**Report: TAB REPORT**  
**Function: Test, Adjust, & Balance**  
**Date: 08/01/2024**

**PROJECT**  
**06-17-24 CAVA YUKON, OK (10TH ST)**

Project: 06-17-24 CAVA YUKON, OK (10TH ST)

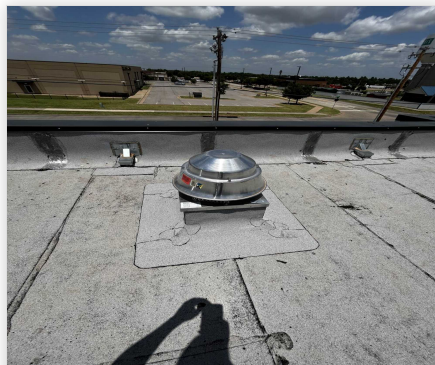
**Issue Name :** EF2  
**Description :** BACK DRAFT DAMPER IS NOT INSTALLED  
**Created By :** National TAB                      **Assigned To :** National TAB - Will Turnbough  
**Status :** Open  
**Priority :** Medium                                      **Asset Tag :**  
**Originated Date :** 06/18/2024 - Kristopher Passley - National TAB

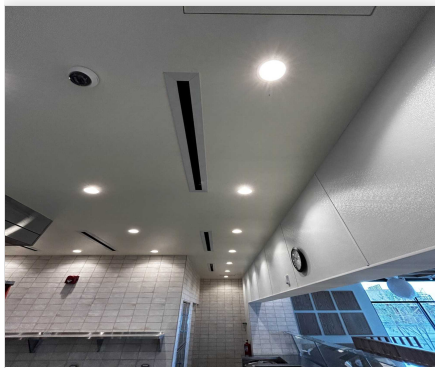
**Issue Name :** EF2 - AIRFLOW  
**Description :** FAN IS ON HIGH AIRFLOW, NO FAN SPEED CONTROLLER INSTALLED. RECOMMEND INSTALLED SPEED CONTROLLER TO BRING FAN INTO DESIGN.  
**Created By :** National TAB                      **Assigned To :** National TAB - Will Turnbough  
**Status :** Open  
**Priority :** Urgent                                      **Asset Tag :**  
**Originated Date :** 06/19/2024 - Kristopher Passley - National TAB

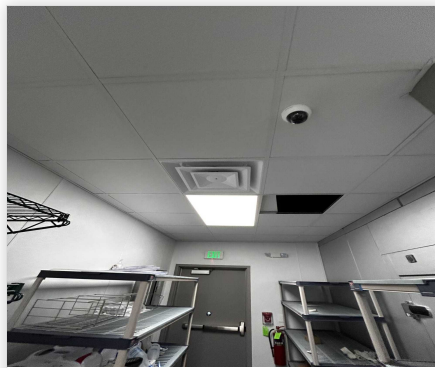
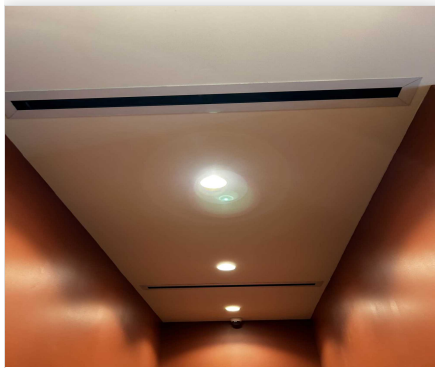
**Issue Name :** RTU-1 KITCHEN DIFFUSERS  
**Description :** KITCHEN DIFFUSERS 1-1,1-2,1-3 and 1-8 HAVE CLOSED DAMPERS THAT ARE INACCESSIBLE. NEED MECHANICAL TO OPEN OR CHECK FOR BLOCKAGE.  
**Created By :** National TAB                      **Assigned To :** National TAB - Will Turnbough  
**Status :** Open  
**Priority :** Urgent                                      **Asset Tag :**  
**Originated Date :** 06/20/2024 - Kristopher Passley - National TAB

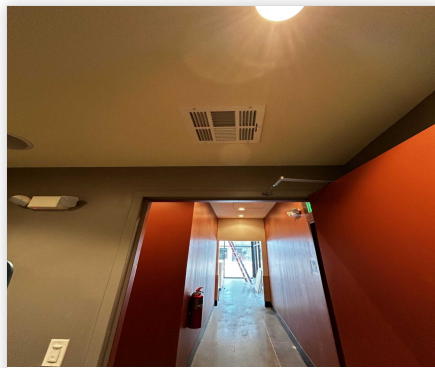
**Issue Name :** RTU-2 DIFFUSERS  
**Description :** RESTROOM AND HALLWAY DIFFUSERS 2-11, 2-12 and 2-14 HAVE CLOSED DAMPERS THAT ARE INACCESSIBLE. NEED MECHANICAL TO OPEN DAMPER OR CHECK FOR BLOCKAGE.  
**Created By :** National TAB                      **Assigned To :** National TAB - Will Turnbough  
**Status :** Open  
**Priority :** Urgent                                      **Asset Tag :**  
**Originated Date :** 06/20/2024 - Kristopher Passley - National TAB
